Our Ref: 175/2026/001/JAH - Please quote in all correspondence.
Planning Ref: 26/00116/FP

13 August 2026

Re: RE: 26/00116/FP - Erection of four detached dwellings and detached garage to serve plot 4 including hard and soft landscaping, parking and creation of vehicular access - 19 Walnut Tree Road, Pirton- Flood Risk Assessment and Drainage Strategy

RE: 26/00116/FP - Erection of four detached dwellings and detached garage to serve plot 4 including hard and soft landscaping, parking and creation of vehicular access - 19 Walnut Tree Road, Pirton

Drawing Number: **175/2026/013** Revision: **P3**

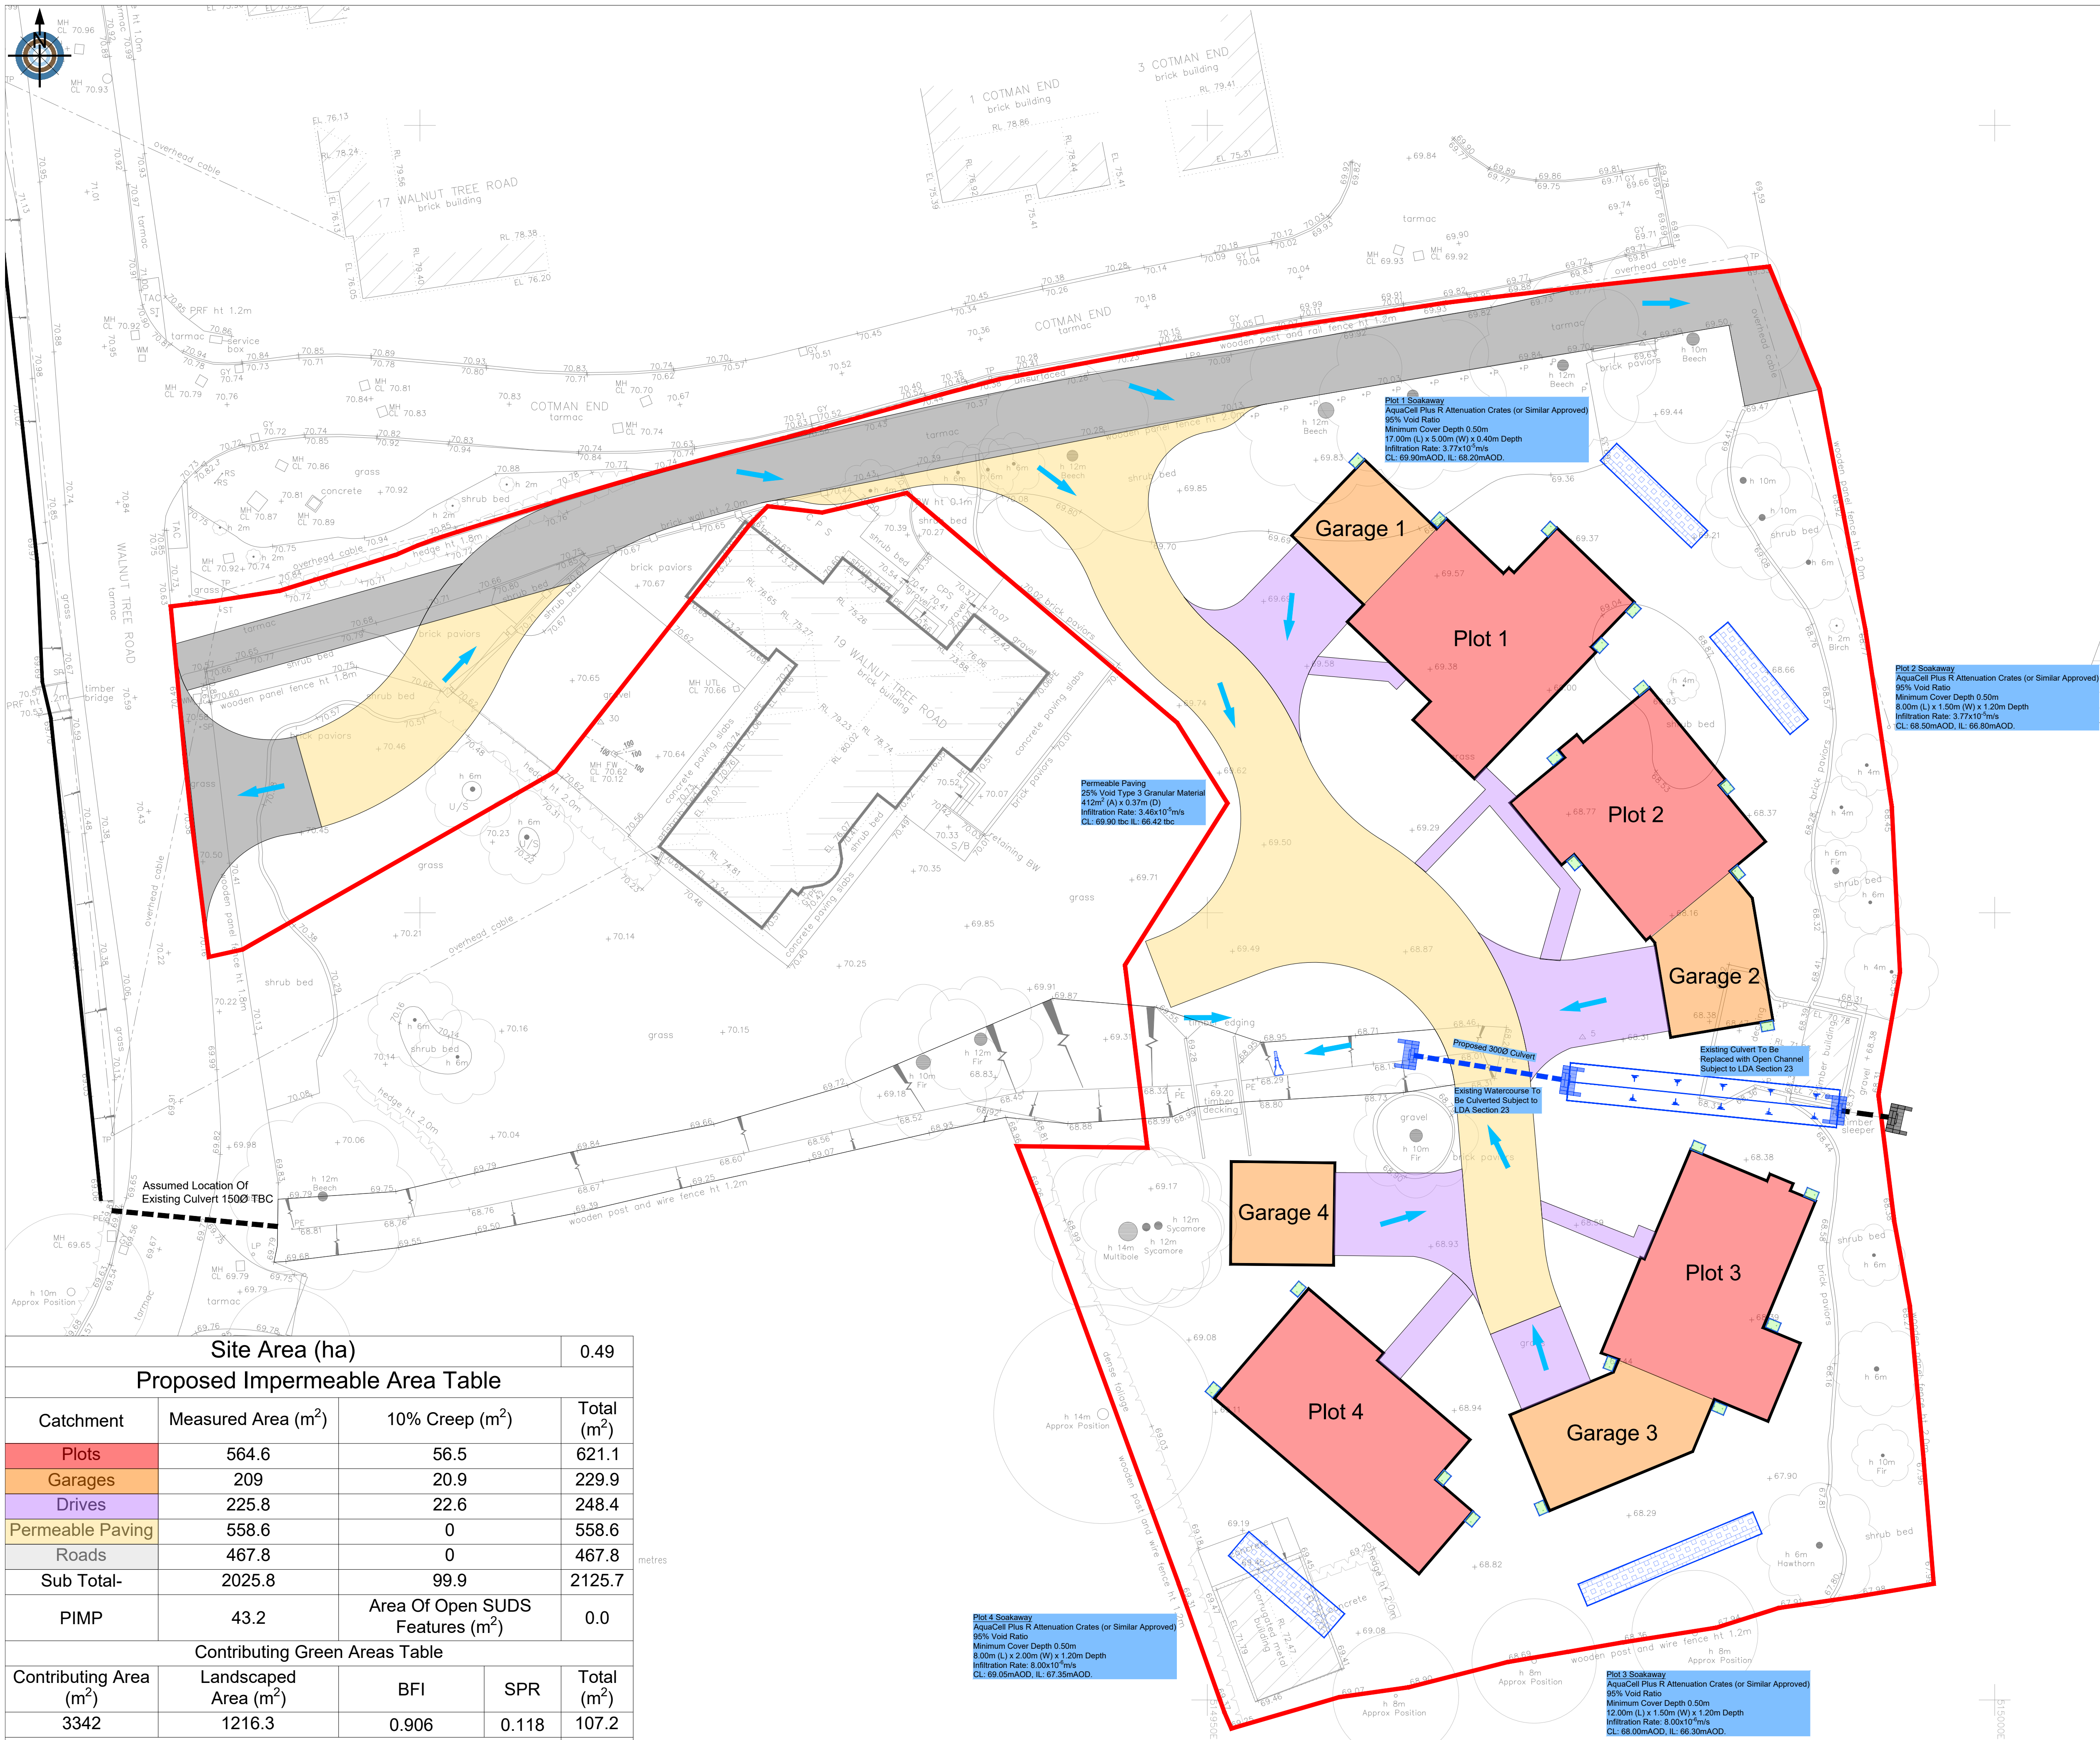
We also note that it is now proposed to culvert a greater length of the existing watercourse to facilitate the road area. We recommend that any culverting is for the minimum length possible. The earlier design with a shorter length of culverting was preferable. Subject to the necessary studies, it may be possible to divert/realign the watercourse to reduce the extent of culverting.

We also note that it is now proposed to culvert a greater length of the existing watercourse to facilitate the road area. We recommend that any culverting is for the minimum length possible. The earlier design with a shorter length of culverting was preferable. Subject to the necessary studies, it may be possible to divert/realign the watercourse to reduce the extent of culverting.

Referring to the attached drawing ref: 175/2026/013 P3, this shows the turning head has been relocated to reduce the encroachment over the existing open watercourse. This has now reduced the length of new culverting required.

P3	12/08/26	Revised Based Upon LLFA Comments	BAF	JAH
P2	15/07/26	Revised Based Upon Client Comments	BAF	JAH
P1	03/07/26	Initial Issue	BAF	JAH
Rev	Rev Date	Description	Drawn	Chck'd

Drawing Number: **175/2026/011** Revision: **P4**

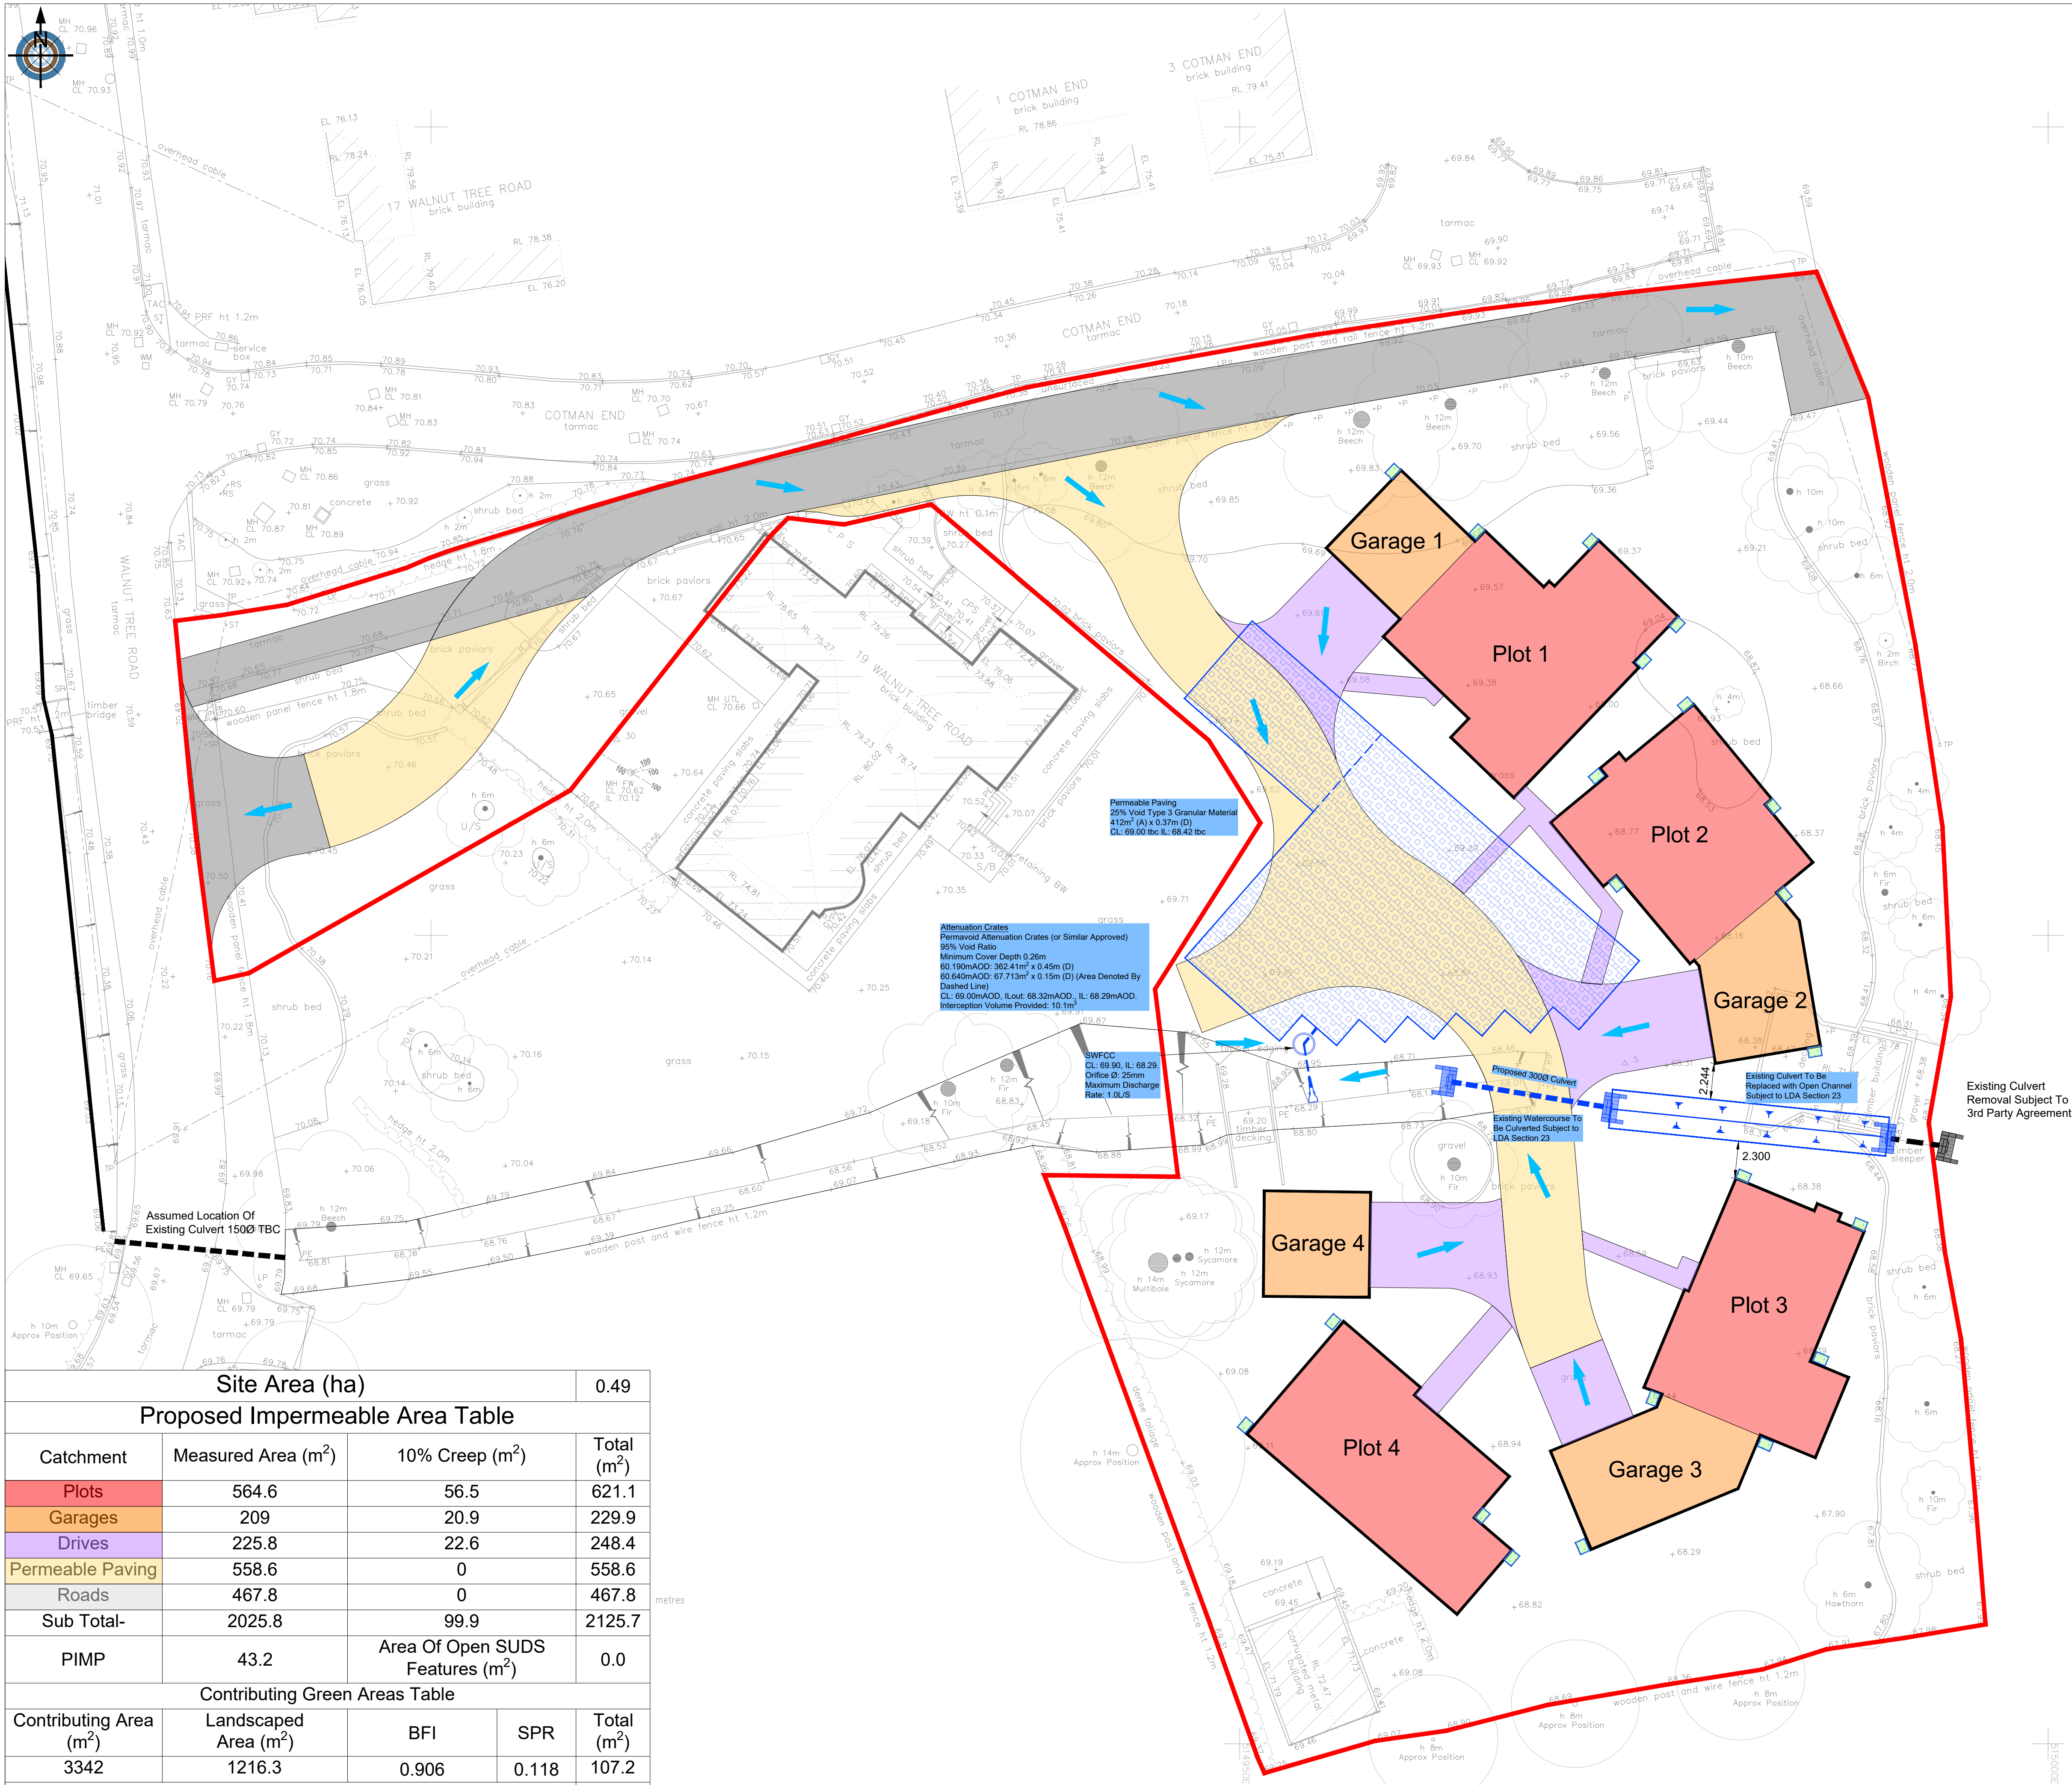
- 1. Secondary drainage strategy discharge rate - We recommend the discharge rate is revisited and restricted as low as possible. We would suggest 1l/s, though we would accept a lower rate where robust maintenance and blockage prevention measures are proposed.*

3. *Maintenance responsibility - We recommend that any SuDS maintenance responsibilities are clearly detailed in the conveyance process/property welcome packs or similar that new residents may receive.*

We recommend the discharge rate is revisited and restricted as low as possible. We would suggest 1l/s, though we would accept a lower rate where robust maintenance and blockage prevention measures are proposed.

We are satisfied that full maintenance details can be secured under condition but recommend clarification of who will be responsible for the proposed attenuation crates. It seems one tank is proposed across the curtilages of both Plots 1 and 2, while the smaller tank is opposite. We highly recommend that attenuation tanks do not cross boundaries such that they become shared features, or that a single resident becomes responsible for a SuDS feature that serves multiple properties. Tanks are likely to require specialist machinery/contractors to inspect and maintain and are costly to replace in the long-term. We recommend that attenuation SuDS serving multiple properties be located in shared areas.

The proposed discharge rate of 16l/s was based on an orifice size of 100mm due to potential blockages. However, a revised design with upstream filtering and a discharge rate restricted to 1 l/s is shown on the attached plan ref: 175/2026/011 P4. The depth of the existing watercourse restricts the depth of attenuation which has been kept shallow. It still utilises the subbase of the permeable paving and then discharges to geo-cellular crates below. Due to the restricted discharge rate this has increased the volume of the attenuation and encroaches into the two of the plots front gardens. The responsibility for the attenuation is discussed within item three below.

The proposed attenuation for the secondary scheme encroaches in the front gardens of plots one and two, as shown on the attached drawing ref:175/2026/011 P4. It is also beneath the access road. The access road will be a shared responsibility with all the plot owners, and they will form part of a management company set-up by the developer. Therefore, the same management company will be responsible for the drainage system and the existing watercourse through the site.

P4	12/08/26	Revised Based Upon LLFA Comments	BAF	JAH
P3	15/07/26	Revised Based Upon Client Comments	BAF	JAH
P2	09/07/26	Alternative Drainage Strategy Options Provided	BAF	JAH
P1	03/07/26	Initial Issue	BAF	JAH
Rev	Rev Date	Description	Drawn	Chk'd
